MEMORANDUM

Organization: Department of Public Works, City of Portsmouth

Re: Middle Street Bike Lane Peer Review

Figure 4: Preferred bike lane alteration near Cabot Street

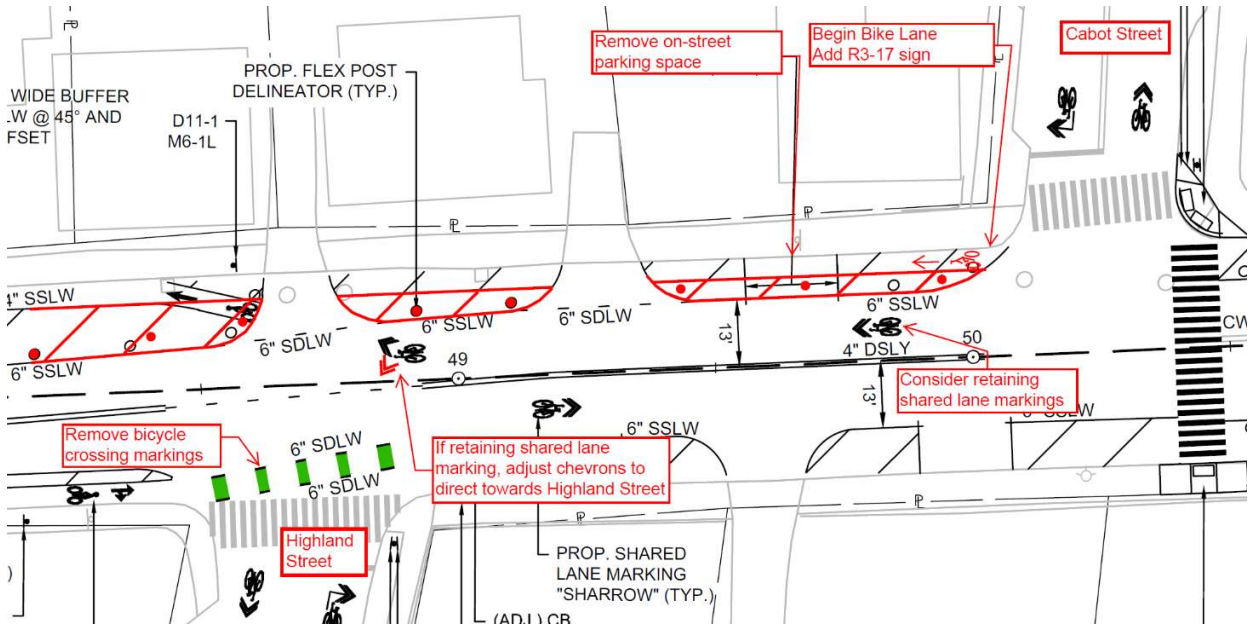
3. **Bike lane alteration near Cabot Street:** The transition for a southbound bicyclist from the shared lane to the separated bike lane near Cabot Street should be adjusted to avoid the transition occurring immediately behind the on-street parking. As depicted in Figure 4, the preferred option would be to remove the on-street parking space immediately south of Cabot Street and begin the bike lane at Cabot Street. Removal of this parking space would maximize the amount of time that a bicyclist is visible to people entering/exiting the on-street parking further to the south. This parking removal would also increase the ISD and SSD at this intersection and help to make pedestrians more visible at the crosswalk. Alternatively, the taper could occur immediately south of this on-street parking space (approximately

Station 49+50), but this would not increase any intersection sight distances at Cabot Street. Although the shared lane markings could be removed from southbound Middle Street in this section, we recommend retaining these markings so that bicyclists already traveling southbound who wish to turn left on Highland Street can more easily make this connection. Bicyclists connecting from Cabot Street to Highland Street

Figure 5: Parking space removal near Madison Street and Middle Street realignment

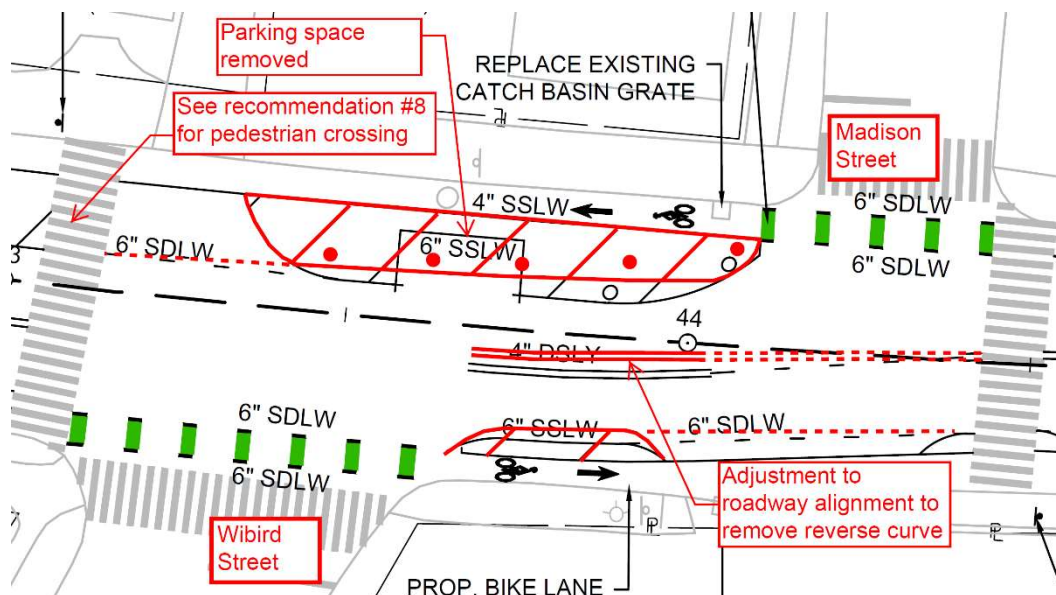
4. **Increase sight distances:** In addition to trimming vegetation at intersections, it is recommended that one (1) on-street parking space be removed south of Cabot and south of Madison Street. At both locations the parking limits sight distances for motorists and can also block sightlines between motorists and crossing pedestrians. Given that the parking space near Madison Street is also designated as a handicapped space, it is recommended that this sign be relocated to the first space on Madison Street. The removal of this parking space will also allow for an adjustment to the horizontal roadway alignment, as depicted in Figure 5, to replace the existing reverse curve with a single horizontal curve, essentially straightening the street for drivers.

Figure 6: Delineator post recommendations approaching and along on-street parking

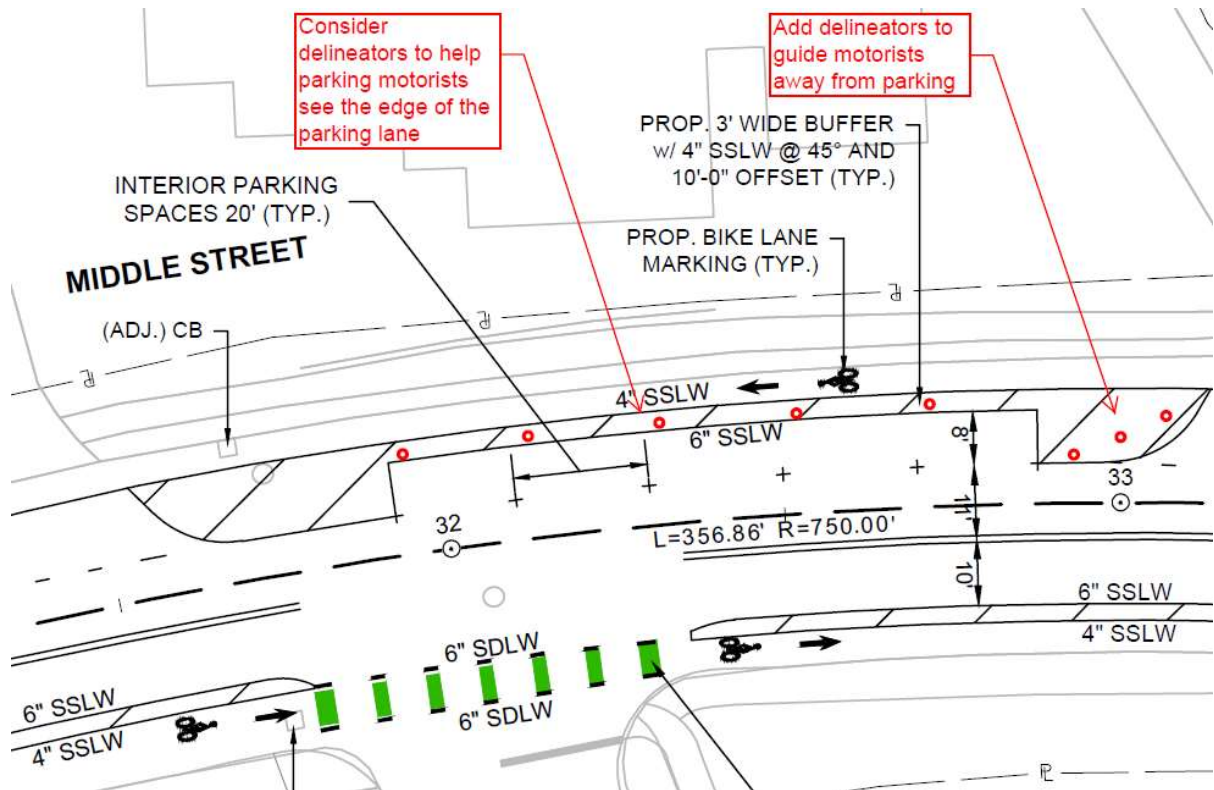
- Delineators to address on-street parking:** The crash data indicates that drivers had struck parked vehicles, particularly at locations where parking is located along the outside of a curve, such as the parking across from Lincoln Ave. Where these conditions exist, consider adding delineators preceding the on-street parking. Although the delineators could be installed along the edge line parallel to the roadway, it may be beneficial to install delineators along a taper (see Figure 6) so that they are more visible to drivers and can guide towards the travel lane. Delineator posts may also be considered within the buffer between the bike lane and on-street parking to help motorists to avoid parking in the buffer. If provided, these delineators should be located near the front wheel of the vehicle to avoid conflicts with opening doors and to maintain access aisles in front of and behind each vehicle.

Figure 8: Pedestrian crossing recommendation for Middle Street at Wibird Street

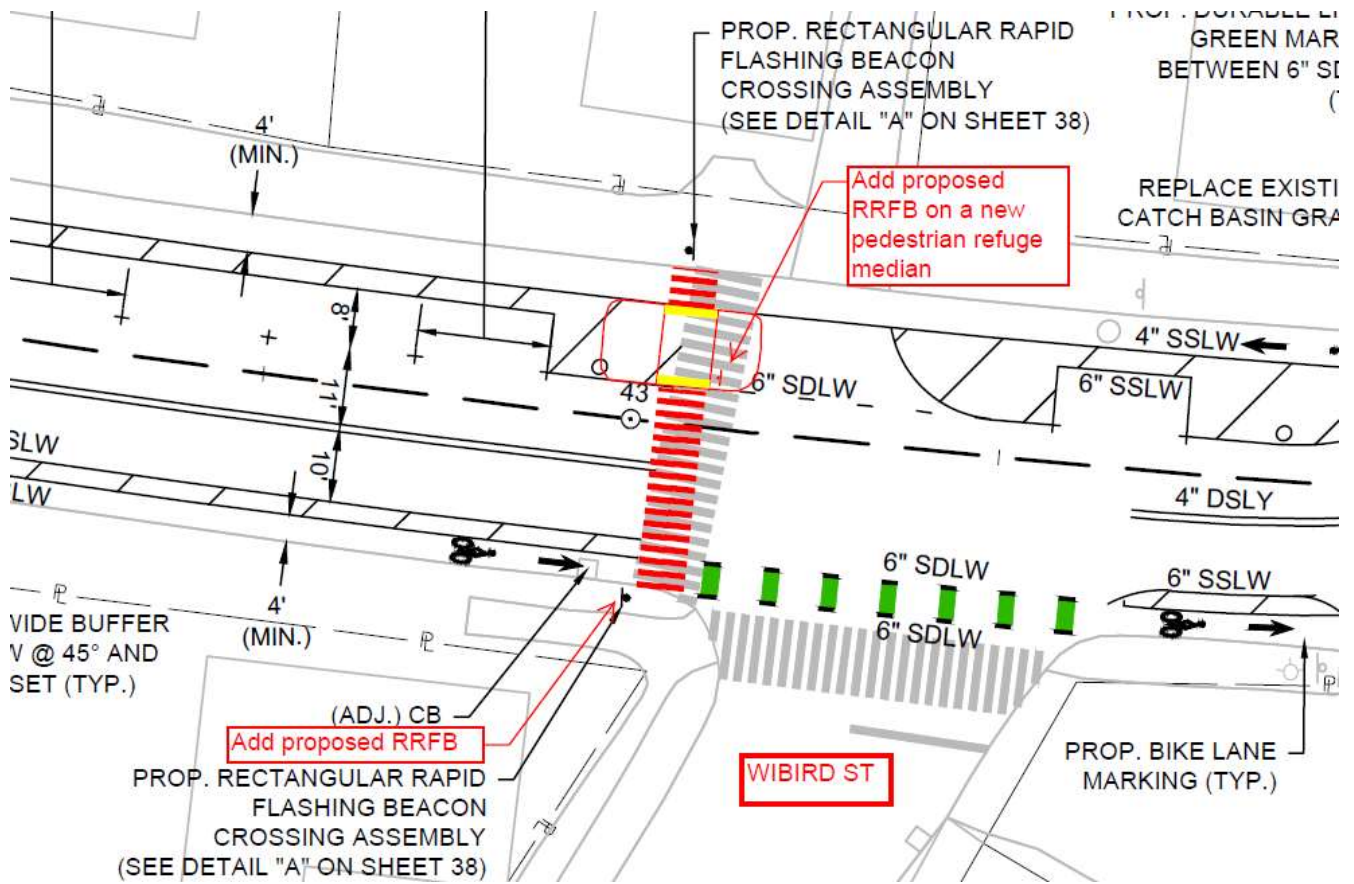
8. **Pedestrian crossing improvement:** The original construction plans identified a Rectangular Rapid Flashing Beacon (RRFB) to be installed for the pedestrian crossing of Middle Street south of Wibird Street. This RRFB was not present at the time of our site visit and should be provided in accordance with the approved plans. However, the on-street parking south of the pedestrian crossing blocks a northbound motorist's view of the pedestrians until they are at the edge of the travel lane, and similarly blocks a pedestrian's view of approaching motorists until they've reached the edge of the travel lane. A pedestrian crossing refuge median should be considered to allow a pedestrian to get closer to the edge of the travel lane to be visible to approaching motorists. If this median is installed, the RRFB sign assembly should be installed on the median as depicted in Figure 8.
